STATE OF FLORIDA DEPARTMENT OF ENVIRONMENTAL REGULATION NOTICE OF PERMIT

Enclosed are permits Nos. AC 54-142282, 54-142283, 54-142288 and 54-142291, for Georgia-Pacific Corporation to construct a No. 3 digesting accumulator and improve the turpentine condenser system for the batch digester system; construct a pre-evaporator stage for the multiple effect evaporation system; construct a condensate stripper system; construct a total reduced sulfur (TRS) incinerator; and construct a noncondensable gas handling system to convey emissions to the TRS incinerator. The action is part of a plan to comply with the TRS Rules adopted on March 21, 1985. The project will be located at Georgia-Pacific Corporation's kraft pulp mill near Palatka, Putnam County, Florida. This permit is issued pursuant to Section 403, Florida Statutes.

Re: Construction Permits Numbers AC 54-142282,
AC 54-142283, AC 54-142288, AC 54-142291 for the Batch
Digester System, the Multiple Effect Evaporation
System, the Condensate Stripper System, and the TRS
Incinerator, Respectively

Figure 1. Flow Diagram of Overall TRS Compliance Program, G-P Palatka Mill

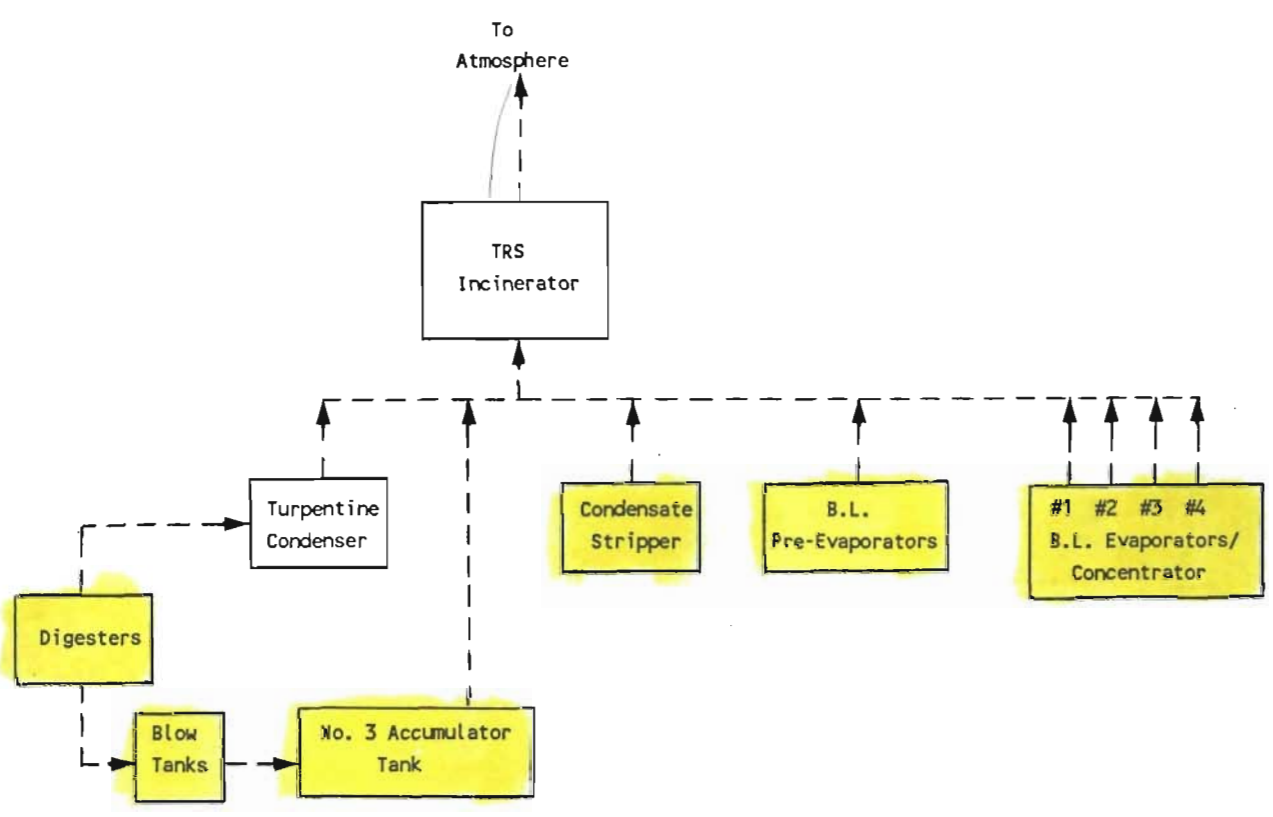
Please explain what happens to the digester if gas is when headward is processed & what happens to the effluent emitted by the No. 12 & No. 13 digesters. Explain how these effluents will be controlled.

control efficiencies
 Pls shw all derivns of all proc Npb rtes & emssn rtes. U will nd 2
 stte, jstfy, & demnt all assumptns. Te max. gs flws frm ech prnttd
 srce z

presently
 Te opern rtes of te dgsters (whch by dfntn Nclde te accmltr tanks &
 turp. condncr system) and ech of te MEE stes (whch by dfntn Nclde te
 clncrtrr appr z hve sbstntilly Ncrsd abve thse spcdl N te MEE opern
 prntes & te 084 Numbeg. Pls descrb all chngs N te methd of operng
 ech system & all chngs z thse systems th hve occrd snc 9/24/76.
 U will nd 2 sprtly qntfy 4 ech prnttd srce te max. actl emssns
 prr z ech chng & te max. emssns afr ech chngg. Te max. actl opern rte
 prr z ech chng, & te max. ^{opern rte} afr ech chng is also z B prdct
 U will nd 2 grv te dce te ech chng occrd. Pls jdnfy anythr
 srces whn te mill tt were affctd by thse chngs & prvd te
 max. hly cgstd N4 mtr crncng opern rtes, emssns, & dces. Also, qntfy te
 chngs N opern rtes & emssns te will occr as a rslt of thse appletns. ^{prjet} ^{descr}

Figure 2. Location of TRS Sources at G-P Palatka Mill

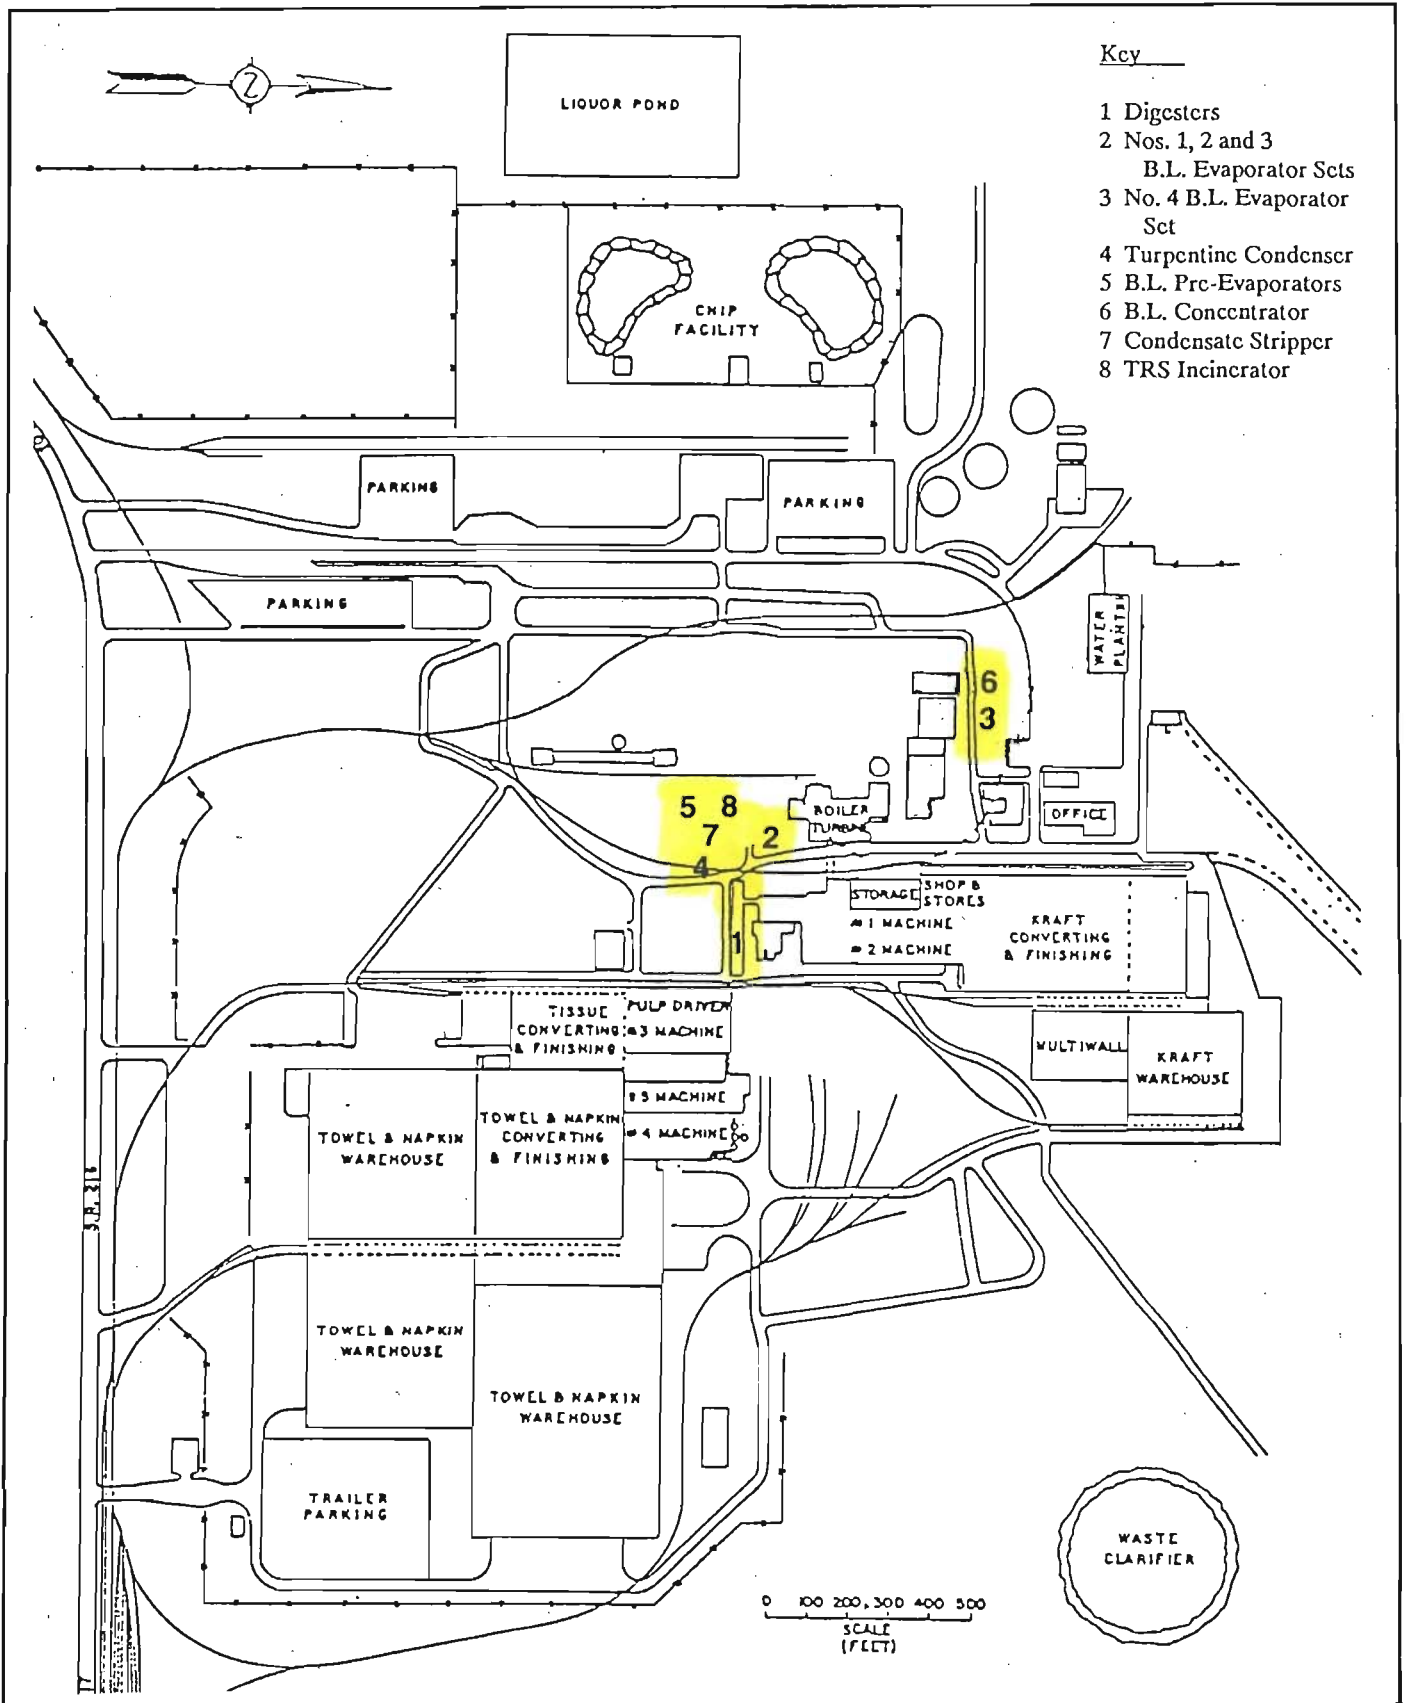
Our applicants & the above referenced construction permits were received on 11/1/87.
We have reviewed these applications & find them to be incomplete. Processing of the applications
will resume upon receipt of the required information. Please show all calculations, see & justify
all assumptions, & provide copies of all documents. Emission calculations. Also include all
pollutants listed in Table 500-2 of FAC Ch. 17-2. Emission rates per 2 each change R 2
B max. actual & emission rates after each change R 2 B max. Operation rates per 2
each change R 2 B max. actual & operation rates after each change R 2 B max. design capacity.
Please provide & show drawings of all process flow sheets, control efficiencies, emissions, &
gas flow rates (ACFM, DSCFM, temp., % H₂O, & FPS).

You will need to provide complete descriptions of the existing sources, the changes to be made,
& the equipment to be installed. This is to include but not be limited to the No., type, make

Ur applictns 4 te rfrnd cnsrctn pnts wre rcvd on 11/187. We hve crwd
thse applictns & fnd thm 2 B Ncmplte. Prssng of thse applictns will rsm
up r cpt of te rgsd N4mtn. Pls shw all cclens, stte all assmptns,
& prude all dcmntn.
